# SUBMISSION

a written submission by way of objection

RE: DA 2024 1829  
6 MONASH PARADE DEE WHY  
WRITTEN SUBMISSION: LETTER OF OBJECTION  
SUBMISSION: TULLOCH

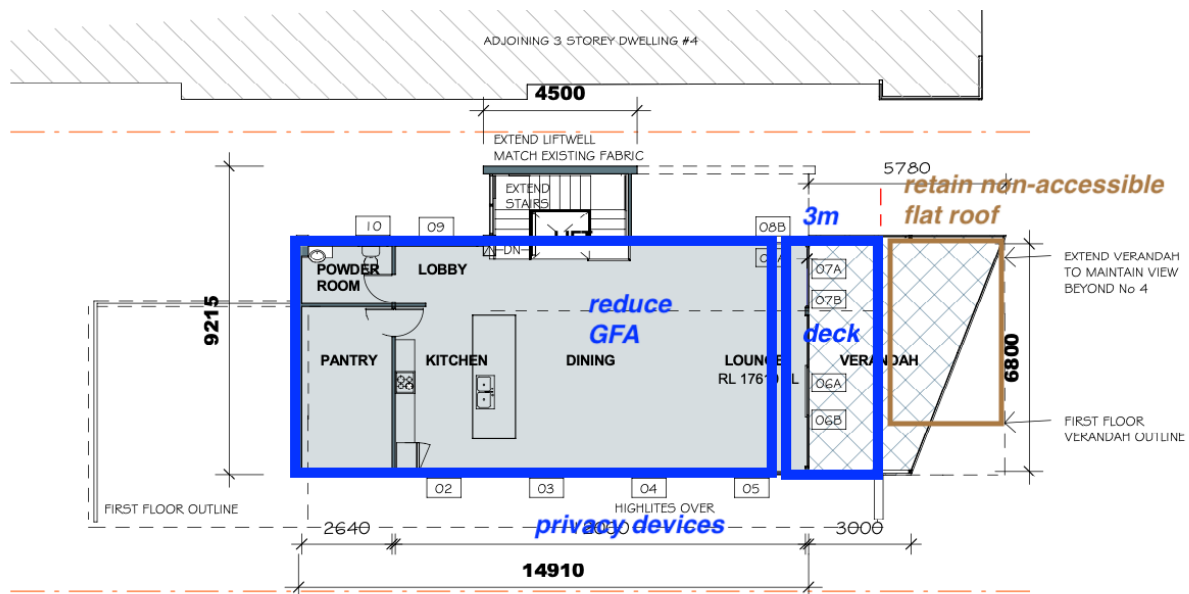
1. The proposed Second Floor Verandah is not to exceed to the east beyond the external wall zone of the existing First Floor Sitting Room
2. The non-accessible existing roof over the First Floor Sitting Room Balcony is to remain.
3. Reduce the Height of Building to LEP standards
4. Reduce the Wall Height to DCP controls
5. Increase Pacific Parade Setback to DCP controls
6. Delete all built from within Side Boundary Envelope to DCP controls

- Maintain built form to two storey, with two levels at 3.1m storey heights, with a pitched roof above, fully according with HOB, WH, Inclined Planes and setbacks, as 8 MONASH PARADE DEE WHY

- All opening and fixed windows facing my client's property to have windows sills increased to a minimum height of 1.7m measured from the internal floor FFL level;
- All glazed windows and doors facing the side boundary are to be fitted with translucent/obscure/frosted glazing to a height of not less than 1.7m measured from the internal floor FFL level;
- 1.7m high fixed louvred privacy screens added to the edge of all balconies facing my clients' property, and extended the full height from finished floor level to the ceiling to any balcony or structure above;
- Fixed louvred privacy screens shall be fixed and angled at a 20-degree acute angle to the angle of the proposed development. All privacy screens are to have fixed louvre blades with a maximum spacing of 25mm, and shall be constructed of materials and colours that complement the finishes and character of the building.

SECOND FLOOR PLAN PROPOSED  
ADDITION

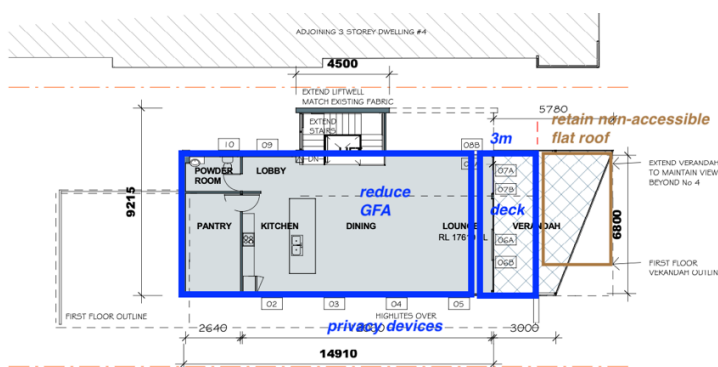
Moderate to Severe

- Excessive Building Height [HOB]: Proposed 9.35m v Control 8.5m [10% non-compliance] \* The only survey levels identified are presented on the Site Plan, however it is uncertain where this information has been obtained from. Extrapolation of levels suggests the built form may exceed HOB. No Clause 4.6 has been submitted.

- Excessive Wall Height [WH]: Proposed 9.05m v Control 7.2m [50% non-compliance] \* The only survey levels identified are presented on the Site Plan, however it is uncertain where this information has been obtained from. Extrapolation of levels suggests the built form may grossly exceed WH. The wall height would be 0.3m below the HOB.

- The proposed Second Floor Verandah is not to exceed to the east beyond the external wall zone of the existing First Floor Sitting Room
- The non-accessible existing roof over the First Floor Sitting Room Balcony is to remain.
- Delete built form to reduce the view loss from the Study
